A Community Review of the Floral Hill Terrace Land Use Application

City File No. ST 26-02 | MHT 26-12 through MHT 26-23 | ARA 26-13

The Project At A Glance

— Solar Lot Standards & Natural Features

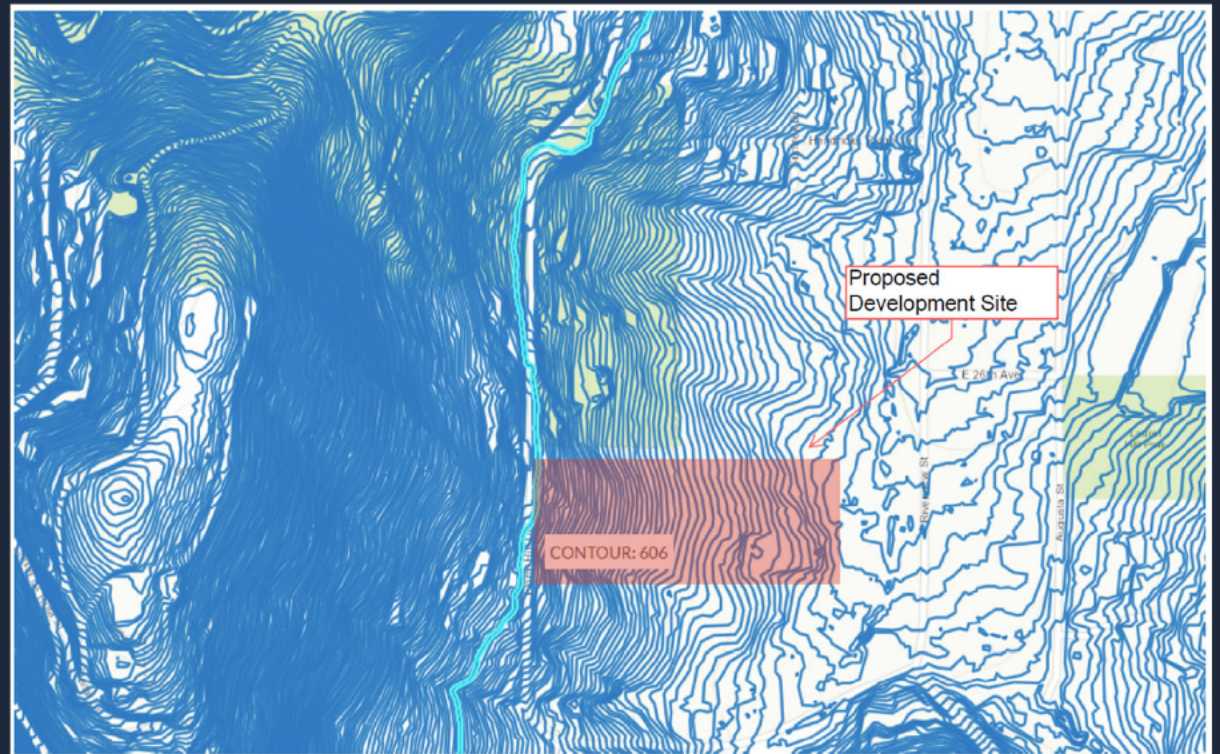
- City found the written statement itself does not address solar lot standards — EC 9.2790 requires a supporting written statement, not just a site plan notation
- An LWI-mapped stream crossing the off-site utility easement corridor has not been resolved with the Oregon Department of State Lands
- Committee recommends confirming whether the mapped wetland area requires delineation under EC 9.8515(7)(f)

Written statement omission and unresolved DSL/wetland coordination.
